IEEE P802.15
Wireless Personal Area Networks

Project	IEEE P802.15 Working Group for Wireless Personal Area Networks (WPANs)	
Title	Spectral mask for FSK	
Date Submitted	[May, 2010]	
Source	[James P. K. Gilb] [SiBEAM] [555 N. Mathilda, Suite 100, Sunnyvale, CA 94085]	Voice: [408-245-3120] Fax: [408-245-3120] E-mail: [last name at ieee dot org]
Re:	[d1P802-15-4g_Draft_Standard.pdf]	
Abstract	[This document describes changes to add an FSK mask to the draft.]	
Purpose	[To resolve comments in LB51.]	
Notice	This document has been prepared to assist the IEEE P802.15. It is offered as a basis for discussion and is not binding on the contributing individual(s) or organization(s). The material in this document is subject to change in form and content after further study. The contributor(s) reserve(s) the right to add, amend or withdraw material contained herein.	
Release	The contributor acknowledges and accepts that this contribution becomes the property of IEEE and may be made publicly available by P802.15.

2. Suggested text for 802.15.4g

Figure 2—2-FFSK modulation

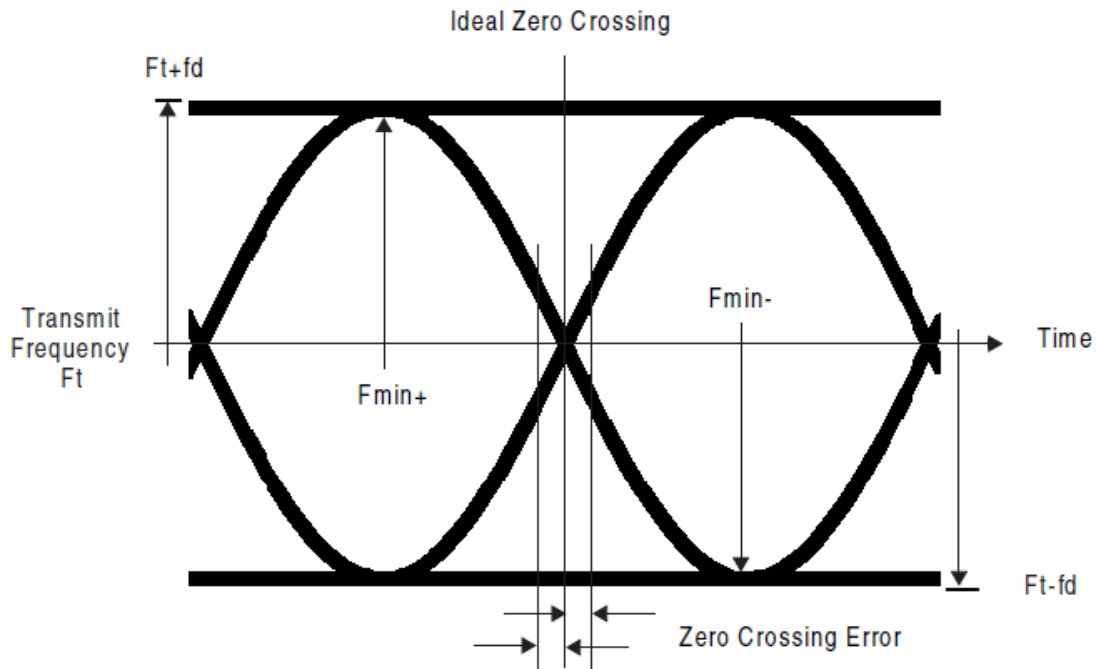
The modulation for MR-FSK is filtered frequency shift keying (FFSK) with either 2 levels (2-FFSK) or 4 levels (4-FFSK). The modulation index for the MR-FSK modes is defined in Table 1a.

The symbols and terms for 2-FFSK signal is illustrated in Figure 2.

For 2-FFSK, the error in the modulation, f_d , shall be less than $\pm 0.1 \cdot (\text{modulation index}) \cdot (\text{symbol rate})$.

The zero crossing error shall be less than $\pm 1/8$ of a symbol period.

Figure 3—4-FFSK modulation

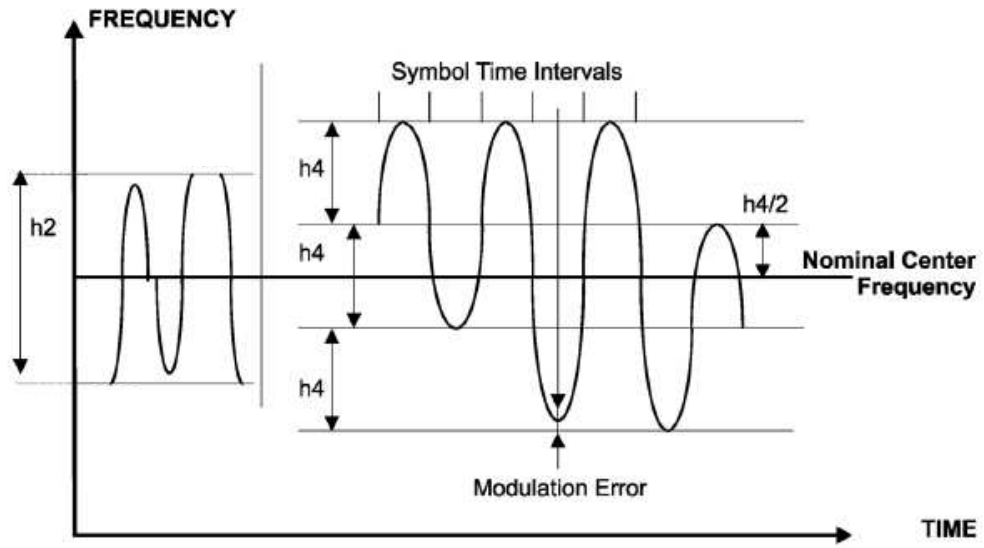
The symbols and terms for 4-FFSK are illustrated in Figure 3.

For 4-FFSK, the error in the modulation shall be less than $\pm 0.1 \cdot (\text{modulation index}) \cdot (\text{symbol rate})$
